UNITED STATES
NUCLEAR REGULATORY COMMISSION
WASHINGTON, D. C. 20555

OCONEE NUCLEAR STATION, UNIT NO. 1

AMENDMENT TO FACILITY OPERATING LICENSE

Amendment No. 38
License No. DPR-38

Figure 3.1.2-1A

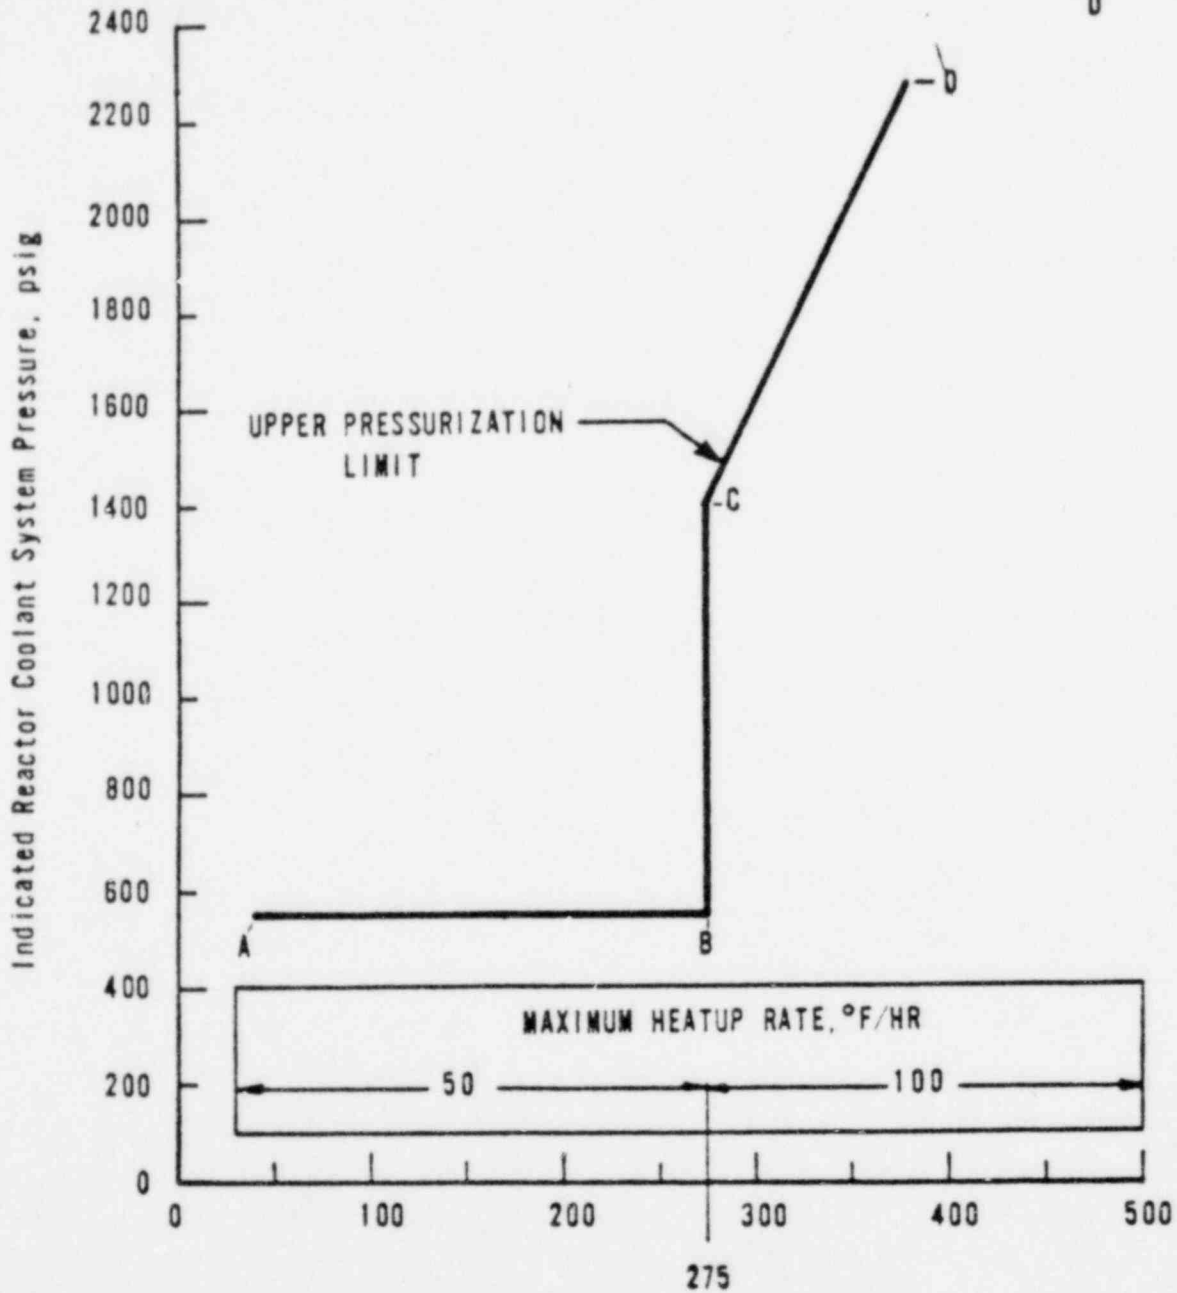
Heatup rates and allowable combinations of pressure and temperatures shall be limited in accordance with Figure 3.1.2-1A Unit 1
3.1.2-1B Units 2&3.

Figures 3.1.2-1A, 3.1.2-2A, and 3.1.2-3 present the pressure-temperature limit curves for normal heatup, normal cooldown and hydrostatic test respectively. The limit curves are applicable up to the fifth effective full power year of operation. These curves are adjusted by 25 psi and 10°F for possible errors in the pressure and temperature sensing instruments. The pressure limit is also adjusted for the pressure differential between the point of system pressure measurement and the limiting component for all operating reactor coolant pump combinations.

The pressure-temperature limit lines shown on Figure 3.1.2-1A for reactor criticality and on Figure 3.1.2-3 for hydrostatic testing have been provided to assure compliance with the minimum temperature requirements of Appendix G to 10CFR50 for reactor criticality and for inservice hydrostatic testing.

POINT	TEMP.	PRESS.
A	40	550
B	275	550
C	275	1400
D	380	2275

Figure 3.1.2-1B

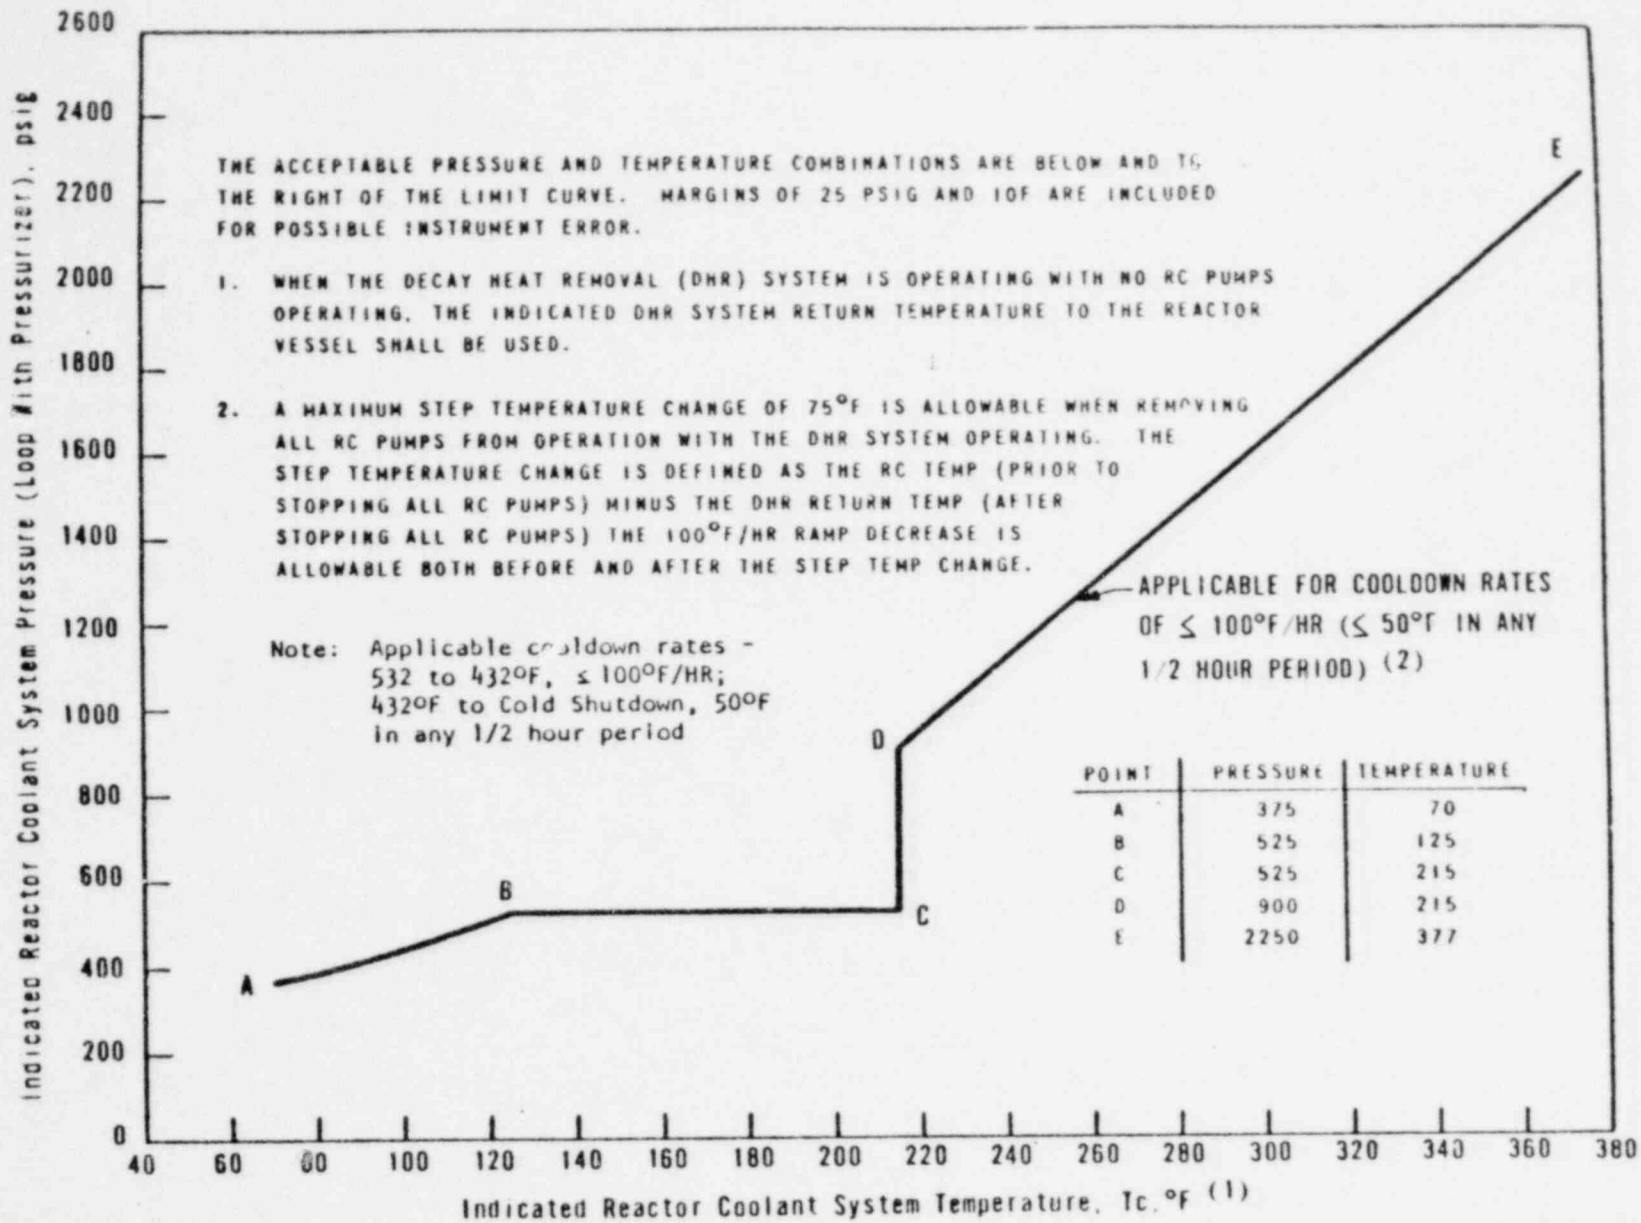
Figures 3.1.2-1B and 3.1.2-2B contain the limiting reactor coolant system pressure-temperature relationship for operation at DTT⁽⁴⁾ and below to assure that stress levels are low enough to preclude brittle fracture. These stress levels and their bases are defined in Section 4.3.3 of the FSAR.

For adequate conservatism in fracture toughness including size (thickness) affect, a maximum pressure of 550 psig below 275°F with a maximum heatup and cooldown rate of 50°F/hr has been imposed for the initial two year period as shown on Figure 3.1.2-1B. During this two year period, a fracture toughness criterion applicable to Oconee Units 2 and 3 beyond this period will be developed by the AEC. It will be based on the evaluation of the fracture toughness properties of heavy section (thickness) steels, both irradiated and unirradiated, for the AEC-HSST program and the PVRC program, and with considerations of test results of the Oconee Units 2 and 3 reactor surveillance programs.

Figure 3.1.2-2A

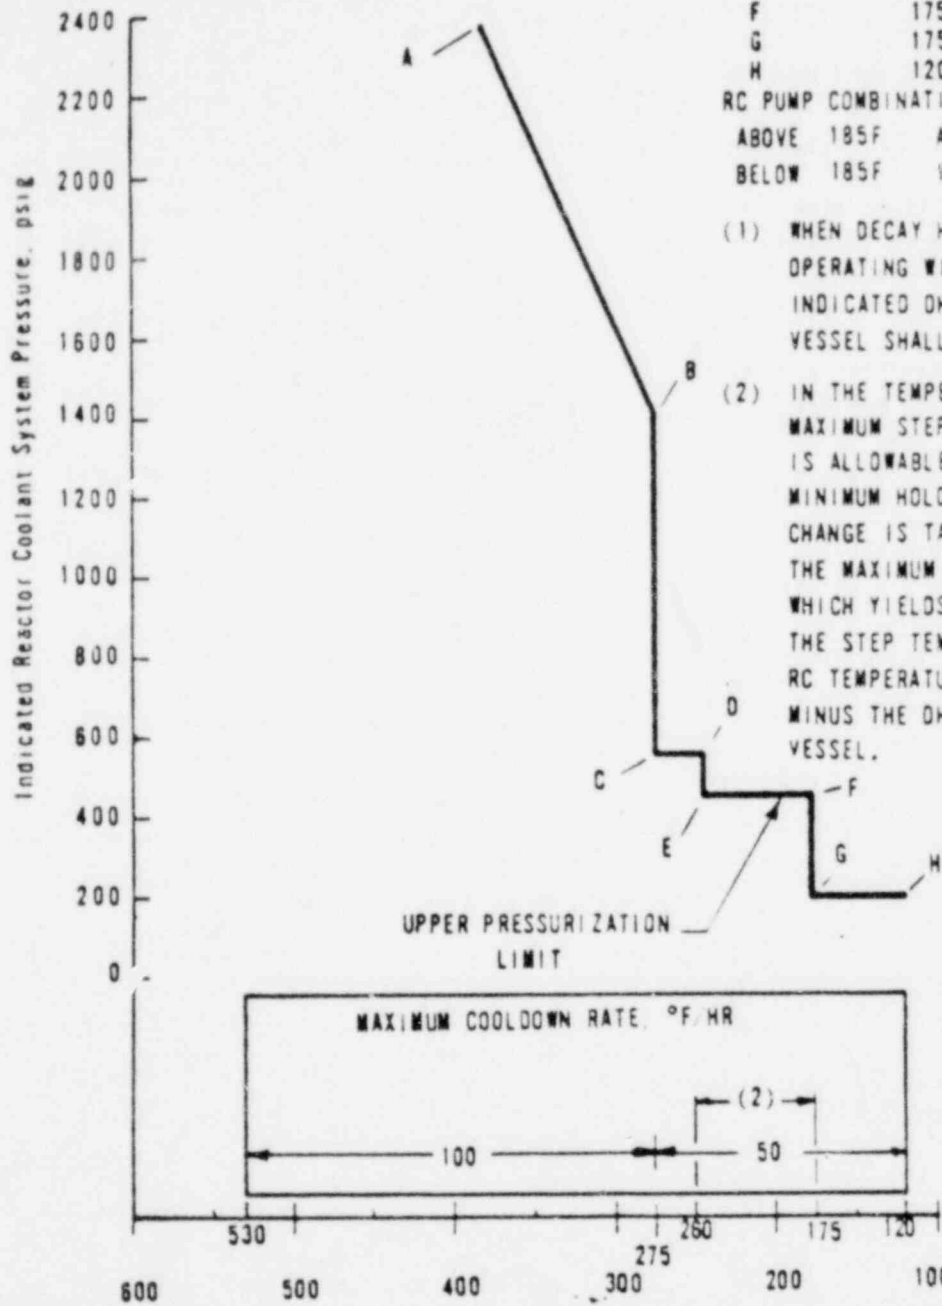
Cooldown rates and allowable combinations of pressure and temperature shall be limited in accordance with Figure 3.1.2-2A Unit 1
3.1.2-2B Units 2&3.

POINT	TEMP	PRESS
A	380	2275
B	275	1400
C	275	550
D	250	550
E	250	450
F	175	450
G	175	200
H	120	200
